**Planning Commission
Staff Report**

August 27, 2014
Item 6.b.

- SUBJECT:** PUD-106
- APPLICANT:** John Gutknecht, Habitec Architecture
- PROPERTY OWNER:** Alameda County Surplus Property Authority
- PURPOSE:** Application for PUD Development Plan for the construction of an automobile dealership consisting of an approximately 31,792-square-foot building with a 2,175-square-foot service canopy and 1,250-square-foot car wash, and related site improvements on the Auto Mall site at Staples Ranch.

Figure 6: Additional Landscaped Area

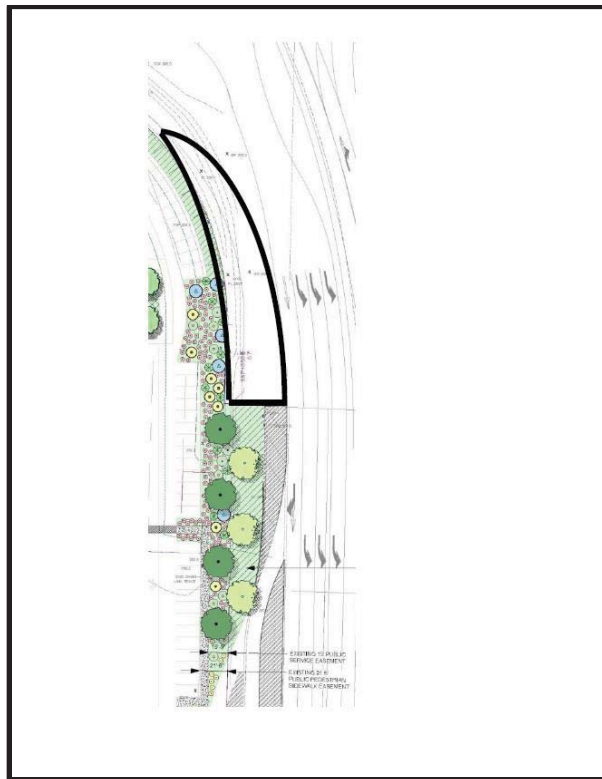
While only 5 of the 16 acre site would be developed at this time, a condition requires that landscaping around the perimeter of the entire 16 acre site be provided. Further, conditions require that if permitted by CalTrans, the applicant provide landscaping at the northeast corner of the 16 acre site, the project site’s I-580 right-of-way, and the “triangle-shaped” area south of the off-ramp as indicated in Figure 6.

As mentioned in this report, a condition requires that the landscaping along the entry drive, Stoneridge Drive, and El Charro Road be clearly identified on permit plans, and that it be consistent in overall appearance and spacing with nearby areas. Further, a condition requires that the project developer contribute to the design and construction of a roadway entry feature near the southeastern corner of the 16-acre site. The feature is intended to be similar (but not necessarily identical) to the feature seen on the City of Livermore side of the Stoneridge Drive/Jack London Boulevard and El Charro Road intersection.
